<b><u>SP-25-08</u></b>	<b><i>Staff Report – March 24<sup>th</sup>, 2025</i></b>
<b><i>Application Type:</i></b>	Special Use Permit Major Site Plan Review
<b><i>Project Address:</i></b>	700-18 Erie Blvd. W & Van Rensselaer
<b><i>Summary of Proposed Action:</i></b>	The applicant and owner of the property located at 700-18 Erie Blvd. W proposes to establish on the subject property as a “parking lot” land use type.
<b><i>Owner/Applicant</i></b>	James Ranalli III, Marcellus Commons, LLC (Owner) CHA Consulting (Applicant)
<b><i>Existing Zone District:</i></b>	Mixed Use Transition(MX-3) Zone District
<b><i>Surrounding Zone Districts:</i></b>	The neighboring properties to the north, south, west and east are within the MX-3 Zone District.
<b><i>Companion Application(s)</i></b>	<b><u>MaSPR-25-02:</u></b> Major Site Plan to construct a parking lot over 10,000 square feet.
<b><i>Scope of Work:</i></b>	The property owner and applicant propose to establish a “parking lot” land use type on the existing site located at 700-18 Erie Blvd. W.

<b><i>MaSPR-25-02</i></b>	<b><i>Staff Report – March 24<sup>th</sup>, 2025</i></b>
<b><i>Application Type:</i></b>	Major Site Plan Review
<b><i>Project Address

**C-101**

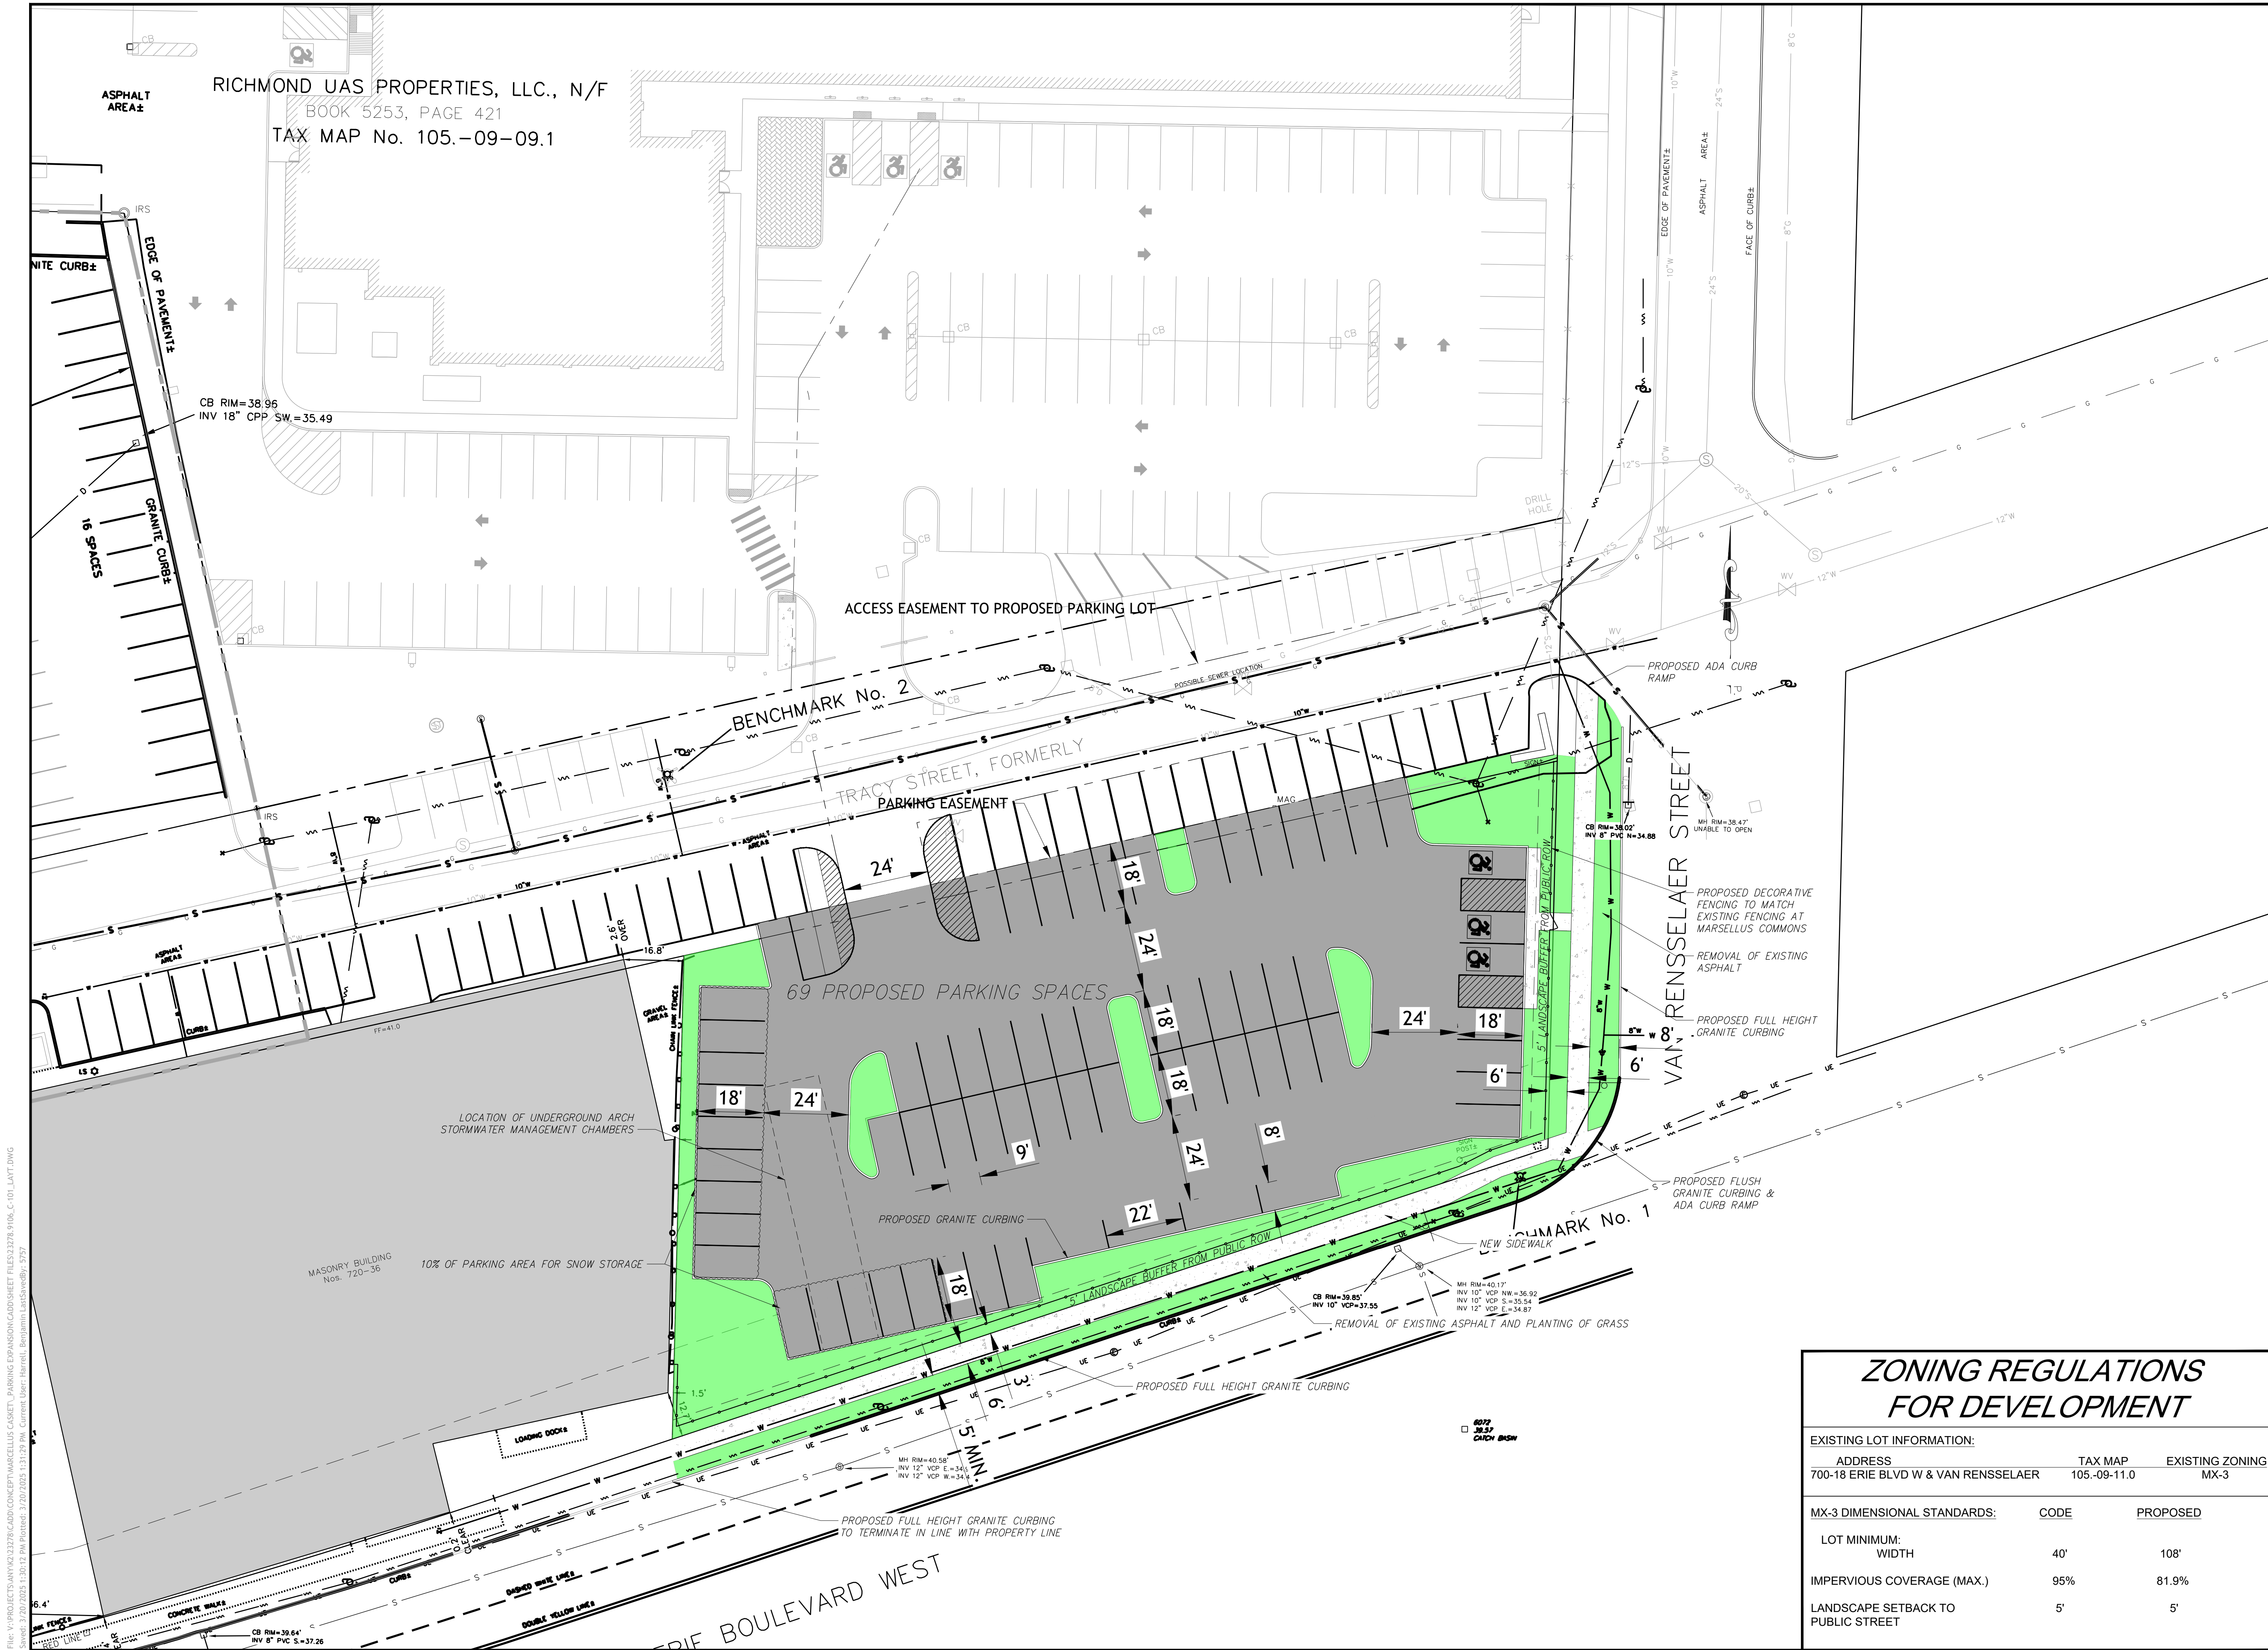
1. Parking lot to be curbed and delineate snow piling areas.  
***Response: Granite curbing has been added to the parking lot and snow piling areas are delineated on the plans.***

2. Parking lot to incorporate necessary accessible stalls.  
***Response: Necessary accessible stalls have been added to the plan.***
3. Public parking lot must incorporate ADA compliant walkway to/from public ROW and any other parcel intended to be served by this lot.

***Response: ADA compliant walkway has been added from new spaces to the public ROW.***
4. A 6' metal fence at the sidewalk edge along a multi-lane arterial roadway is not an acceptable streetscape design.

5. Fencing to be offset from sidewalk edge 3'+ for maintenance and pedestrian needs. Sidewalk 6' wide with 5' or greater snow storage, with ADA compliant curb ramps.

6. Full height curbing to be replaced along entire frontage, current plans propose retaining drop curb along Erie Blvd E. at the western edge of the parcel.

***Response: Fencing will be less than 6' in height, will match existing fence height but has been moved back from the sidewalk to provide an acceptable streetscape design.***

***Response: Fencing has been setback from the sidewalk edge at least 3' to provide area for maintenance and pedestrian needs. The sidewalk has been widened to 6' and maintains a***

***minimum 5' for snow storage along with ADA compliant curb ramps at the corner and driveway crossing along Van Rensselaer Street.***

***Response: Full height curbing has been extended the entire length of the property along Erie Blvd.***

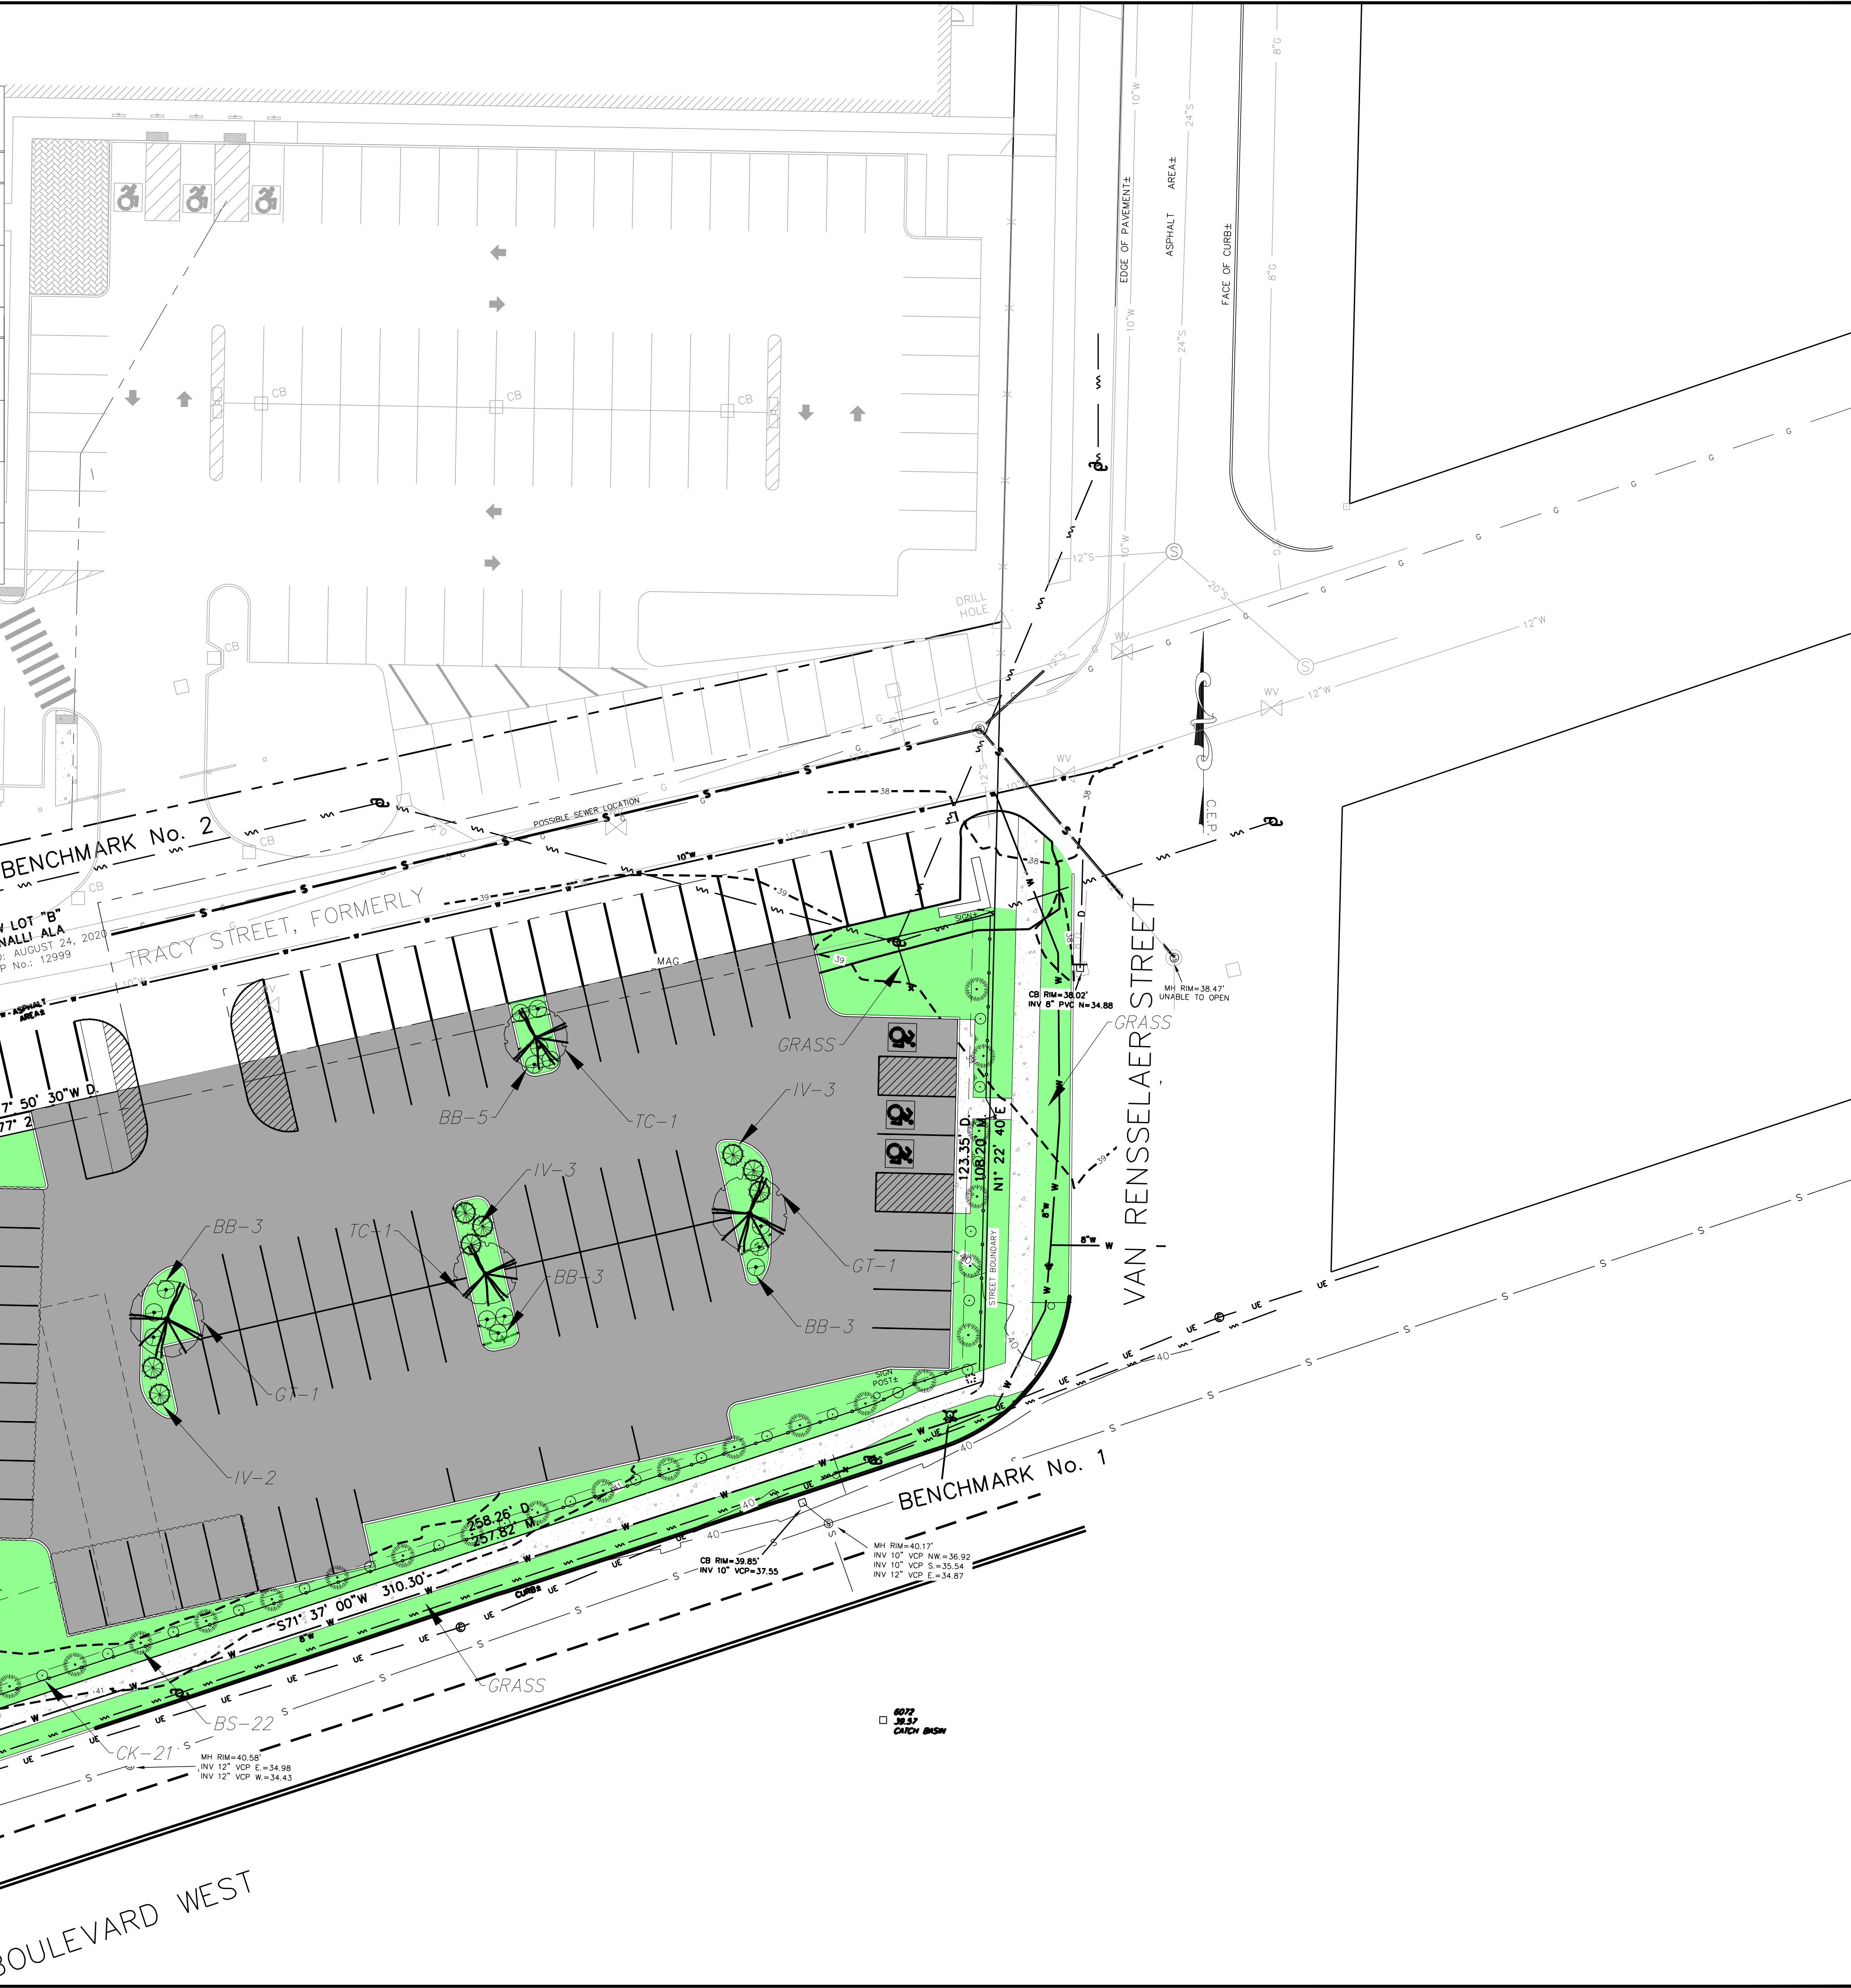
1. Forestry requires CU soils under proposed sidewalks on both frontages; Van Rensselaer and Erie Blvd W. within the new tree lawns; excavate existing soils to the depth of 3' feet and provide new soils to grade. Provide 3 shade trees along Van Rensselaer and 8 shade trees along Erie Blvd, placed approximately 30' on center. Recommended species; Hackberry, Burr Oak, Katsura. Consider replacing Red Maple (over-represented) with Kentucky Coffee tree (Espresso-non fruiting).

2. Planting schedule quantities do not add up, revise.

***Response: There are water mains directly below new tree lawns and overhead wires directly above along Erie Blvd, owner is not opposed to providing CU soils under sidewalks and street trees but further coordination with the water department and engineering department seems necessary prior to planting over mains. Red Maple has been substituted for honey locust.***

***Response: Planting schedule has been revised.***
